**Development Application for Consideration by the
Planning Commission**

Project Name: Phoenix Training Facility

Project Description & Action Requested of the PC: To grant site plan approval for a new 5,000 square foot commercial office building and future addition.

DATE: January 15, 2026
TO: Mr. Pet Elam
FROM: Rick Solle, Director of Public Services
SUBJECT: 3973 Butternut Drive Site Plan Review

UTILITY PLAN
FOR
3963 & 3973 BUTTERNUT DR.
PLAINFIELD TOWNSHIP, KENT COUNTY, MICHIGAN

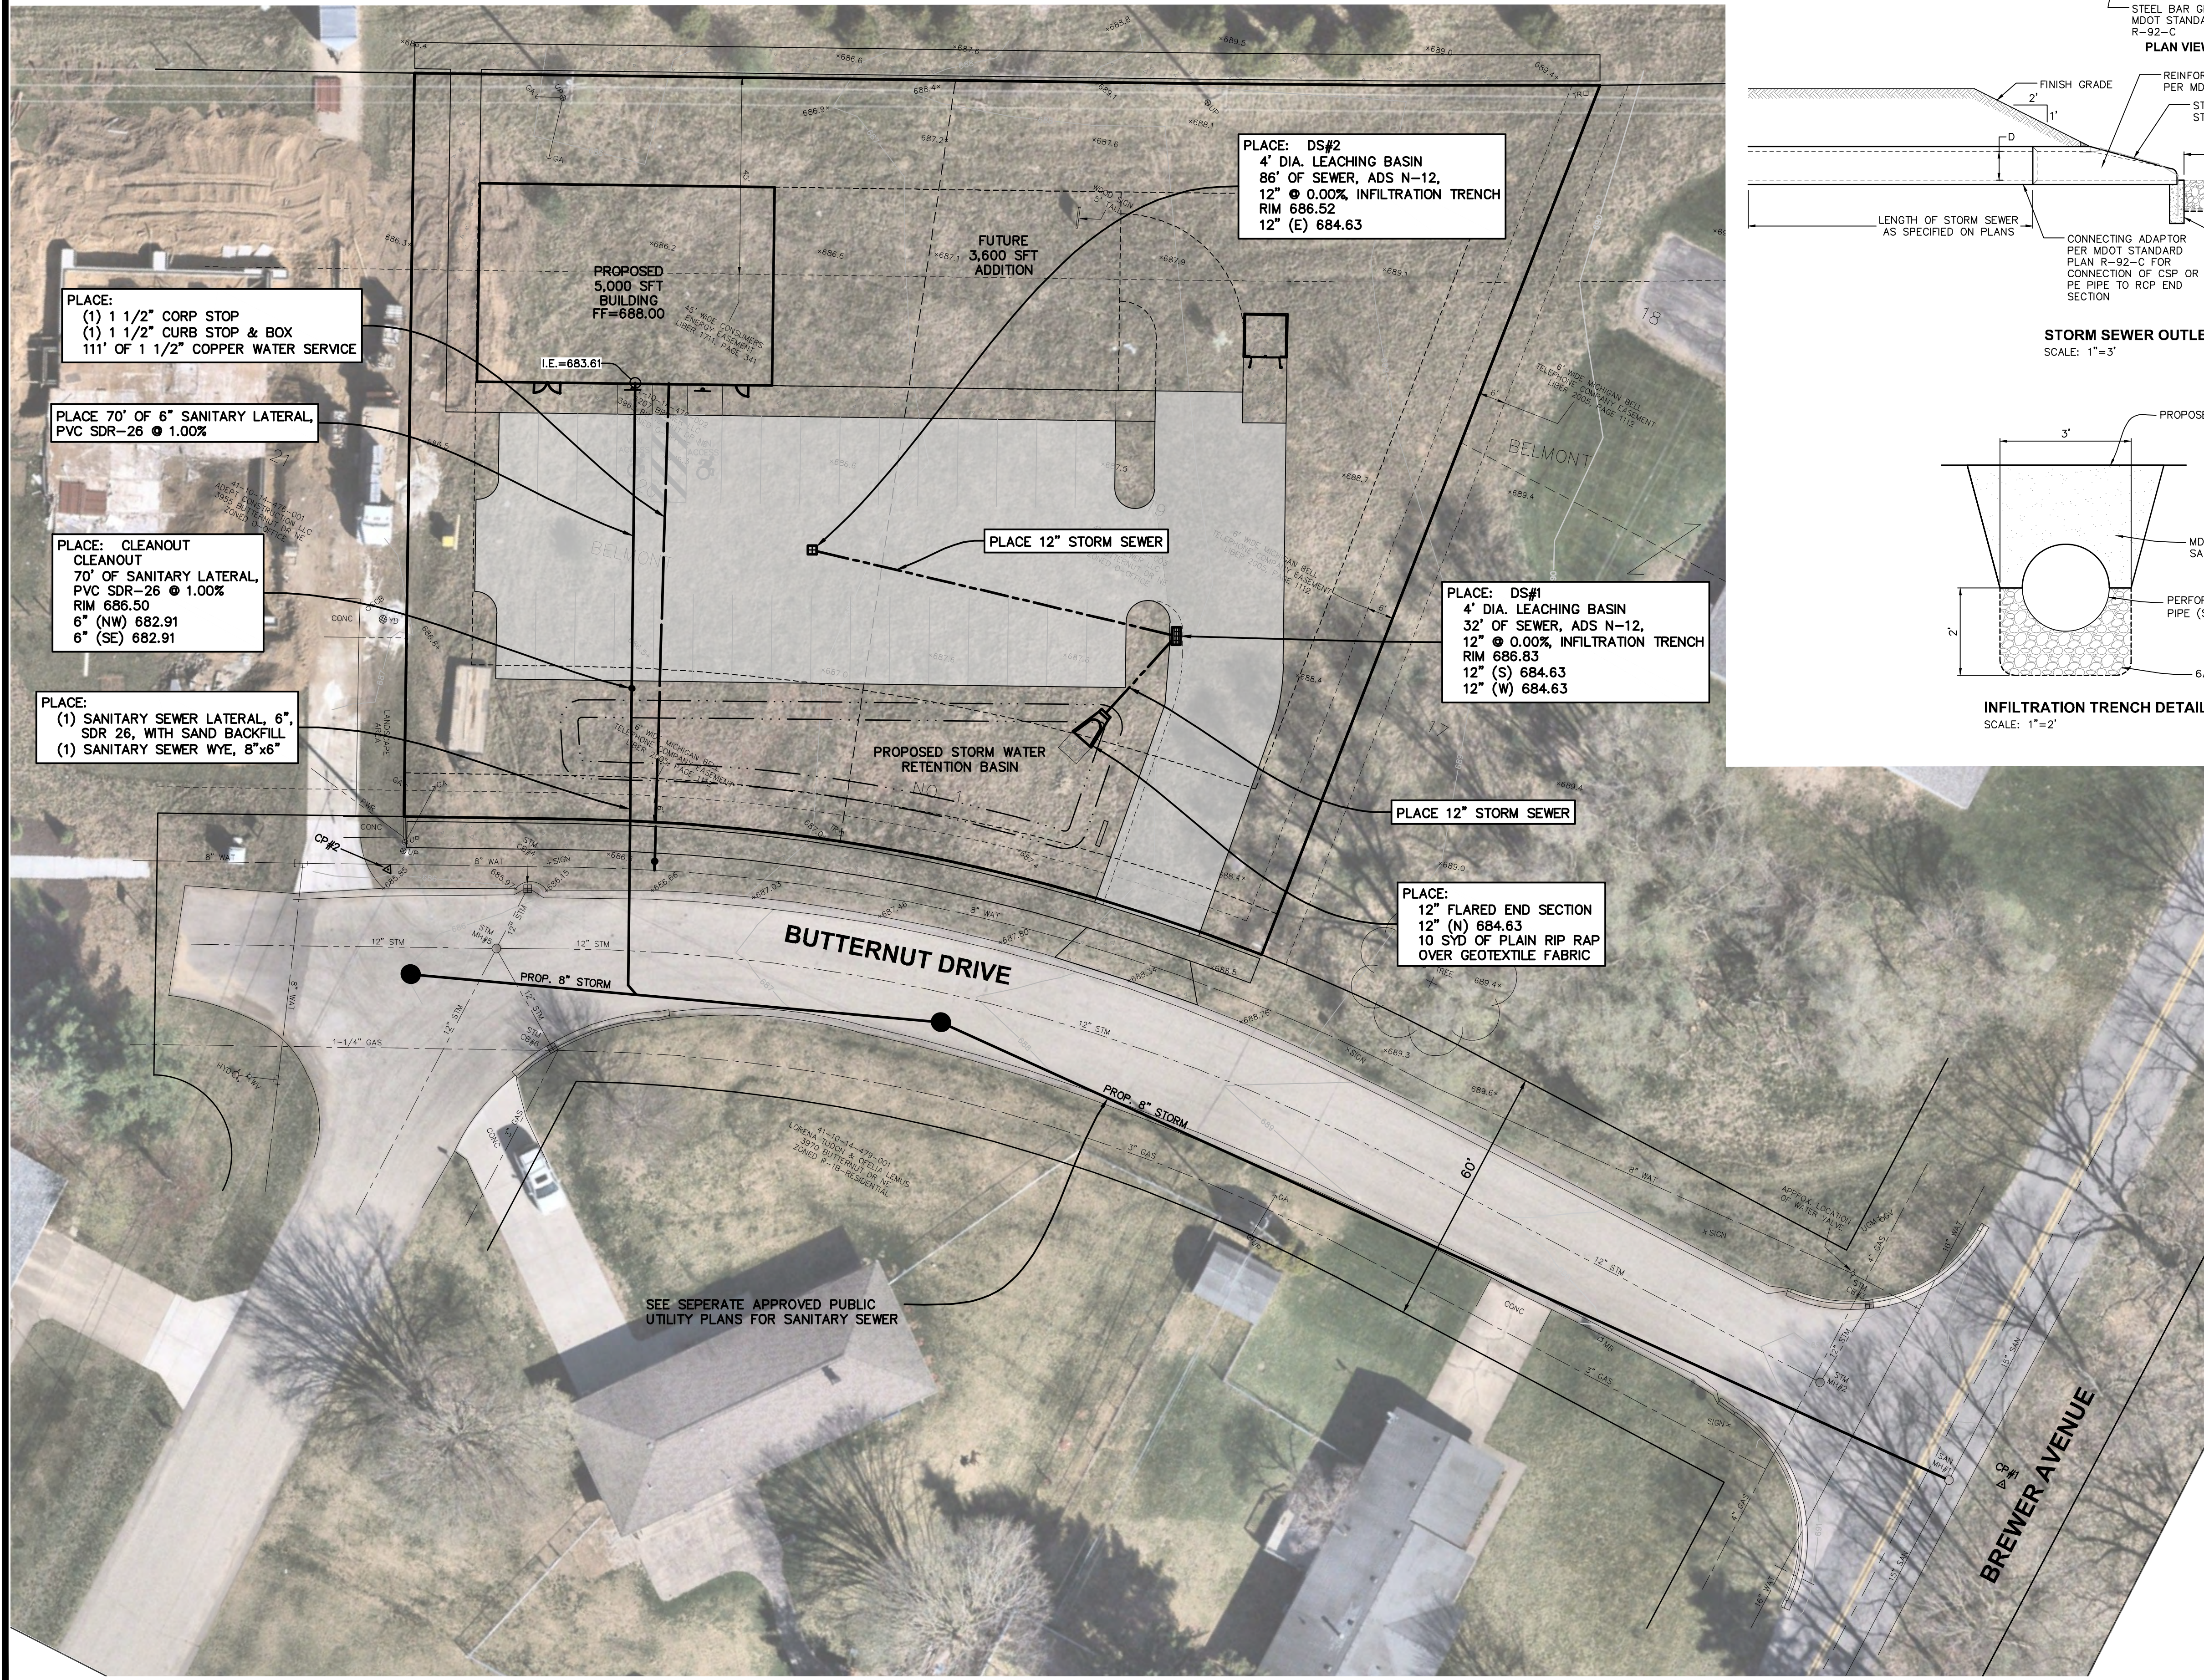
- There is an existing water main in Butternut Drive that is available for connection.

- The proposed connection to the existing sanitary sewer in Brewer Avenue is feasible for service to this property.
- The cost of the sewer extension in Brewer Ave and in Butternut Drive will be the responsibility of the developer.
- Plans and specifications for the proposed extension will need to be reviewed by the Township prior to installation and a permit will be required from the state.

STORM WATER RETENTION BASIN
FOR
3963 & 3973 BUTTERNUT DR.
PLAINFIELD TOWNSHIP, KENT COUNTY, MICHIGAN

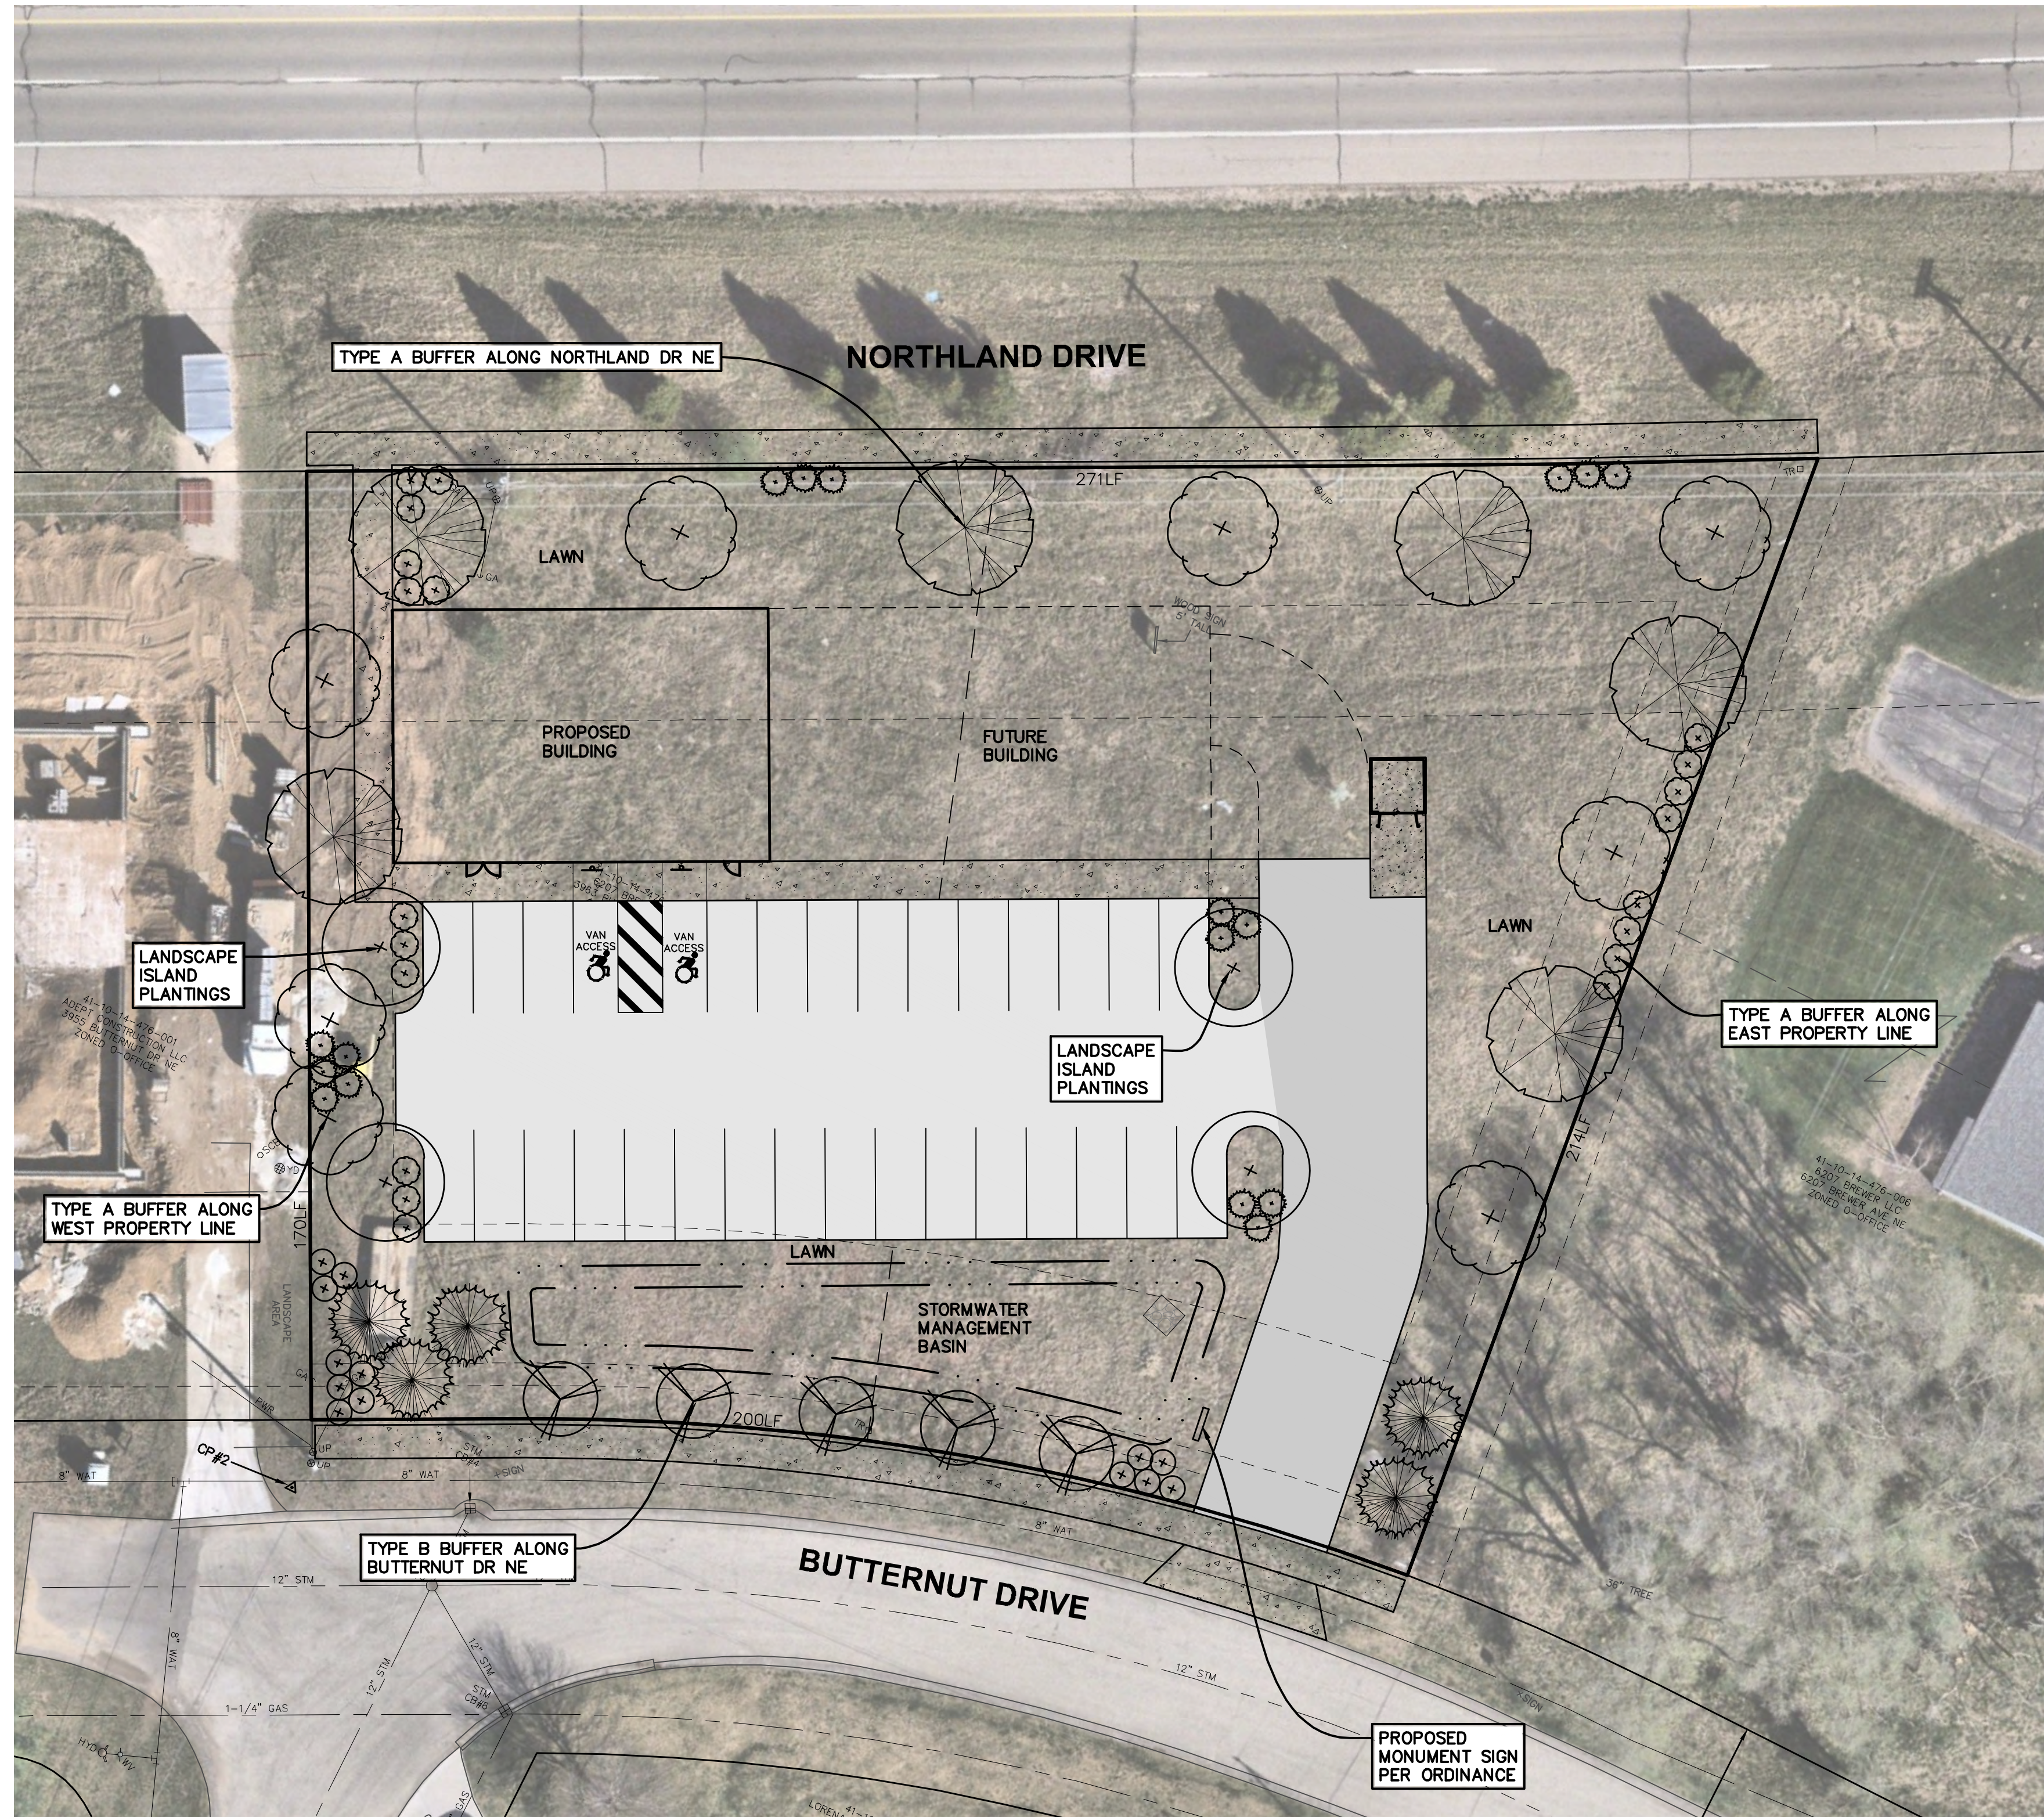
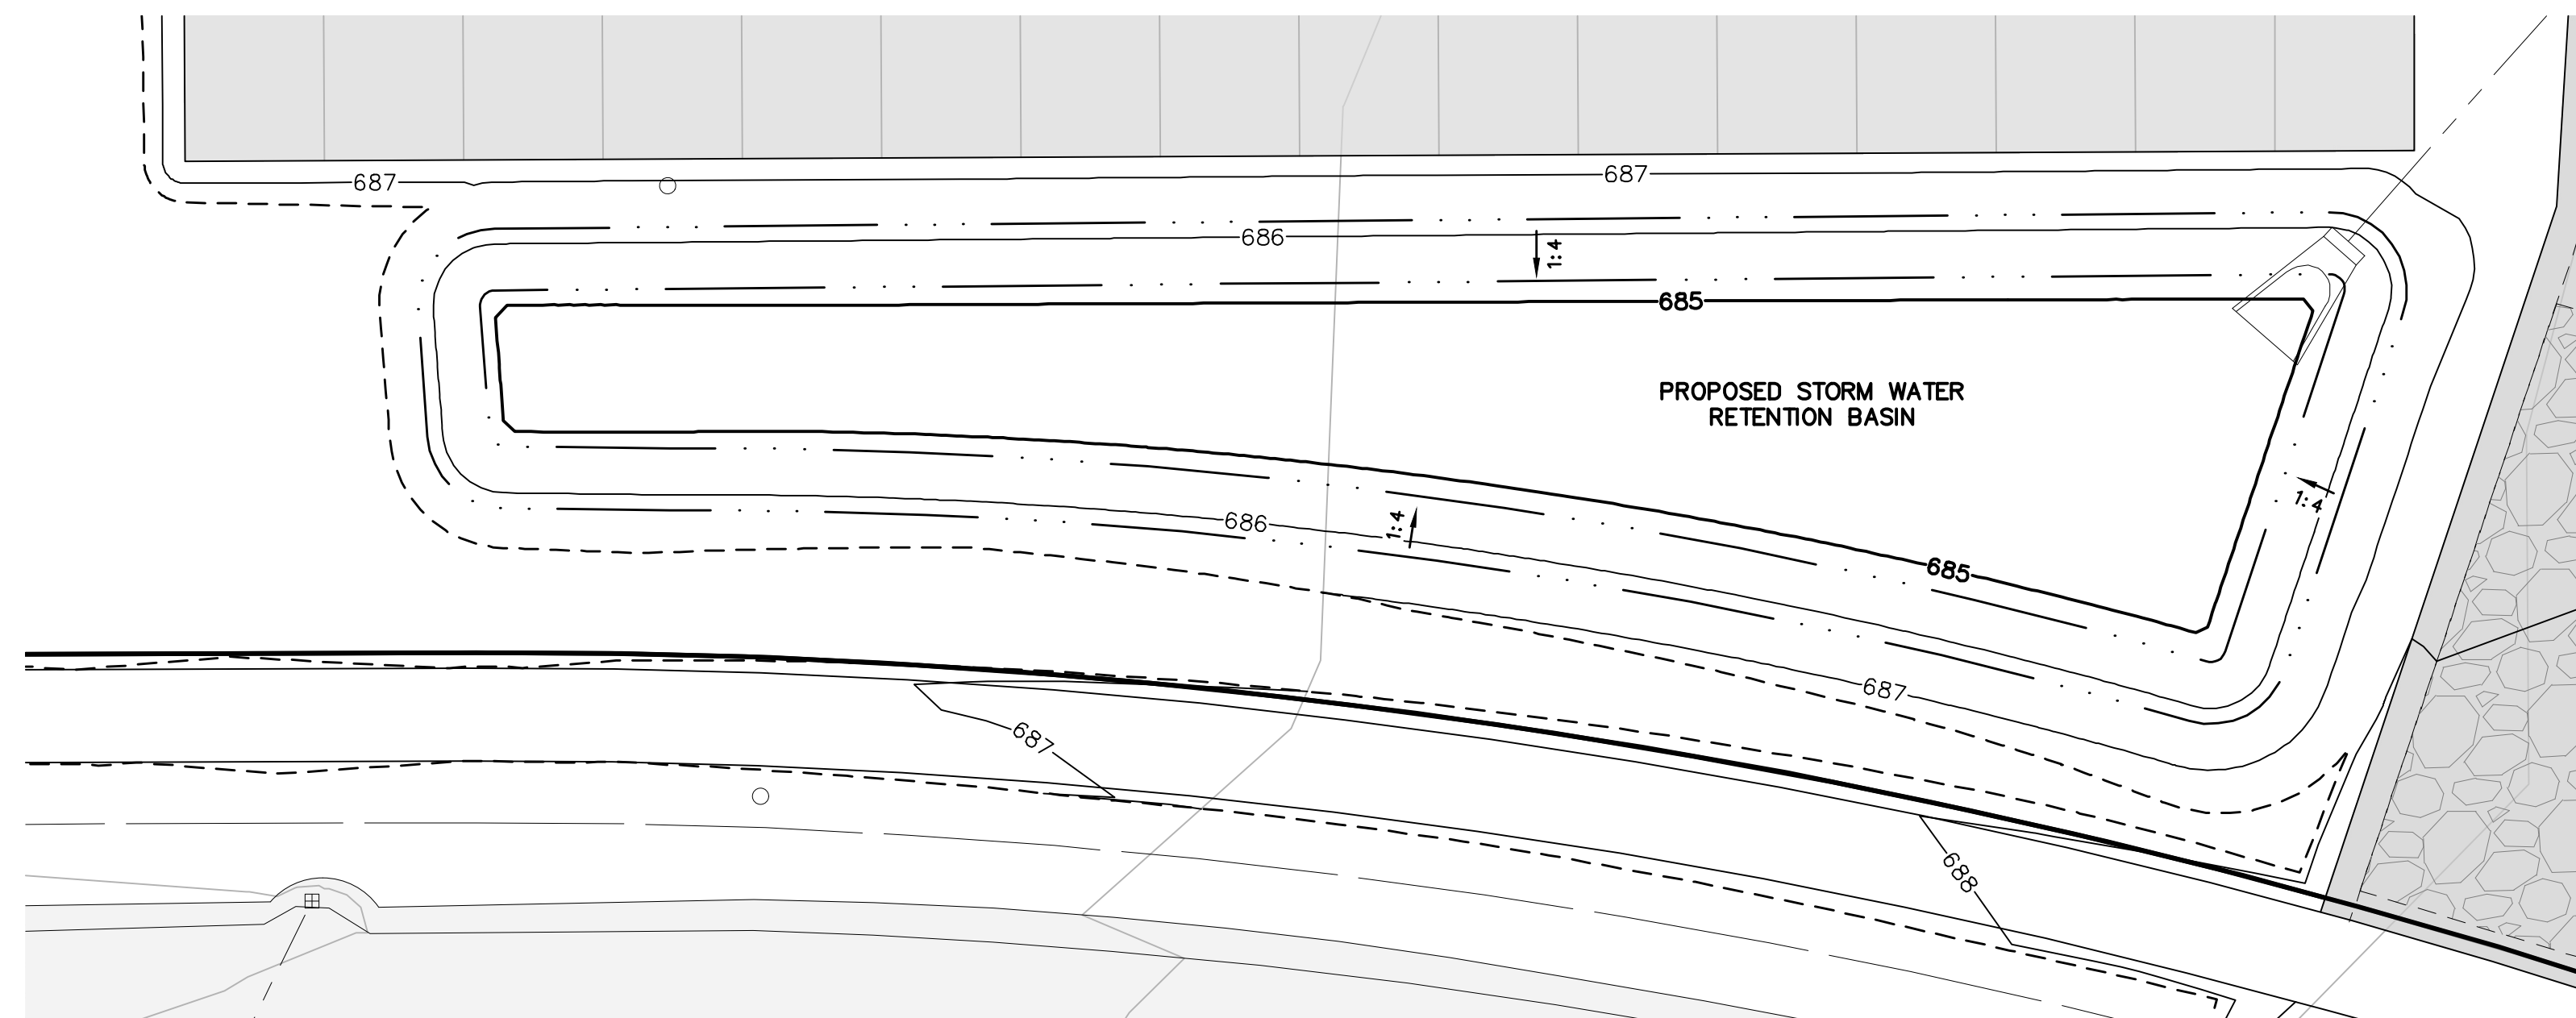
- The site will be required to have stormwater management facilities and the final design with stormwater calculations will need to be reviewed and approved prior to construction.
- A Stormwater Permit will be required for this project, including an Operation & Maintenance Agreement.
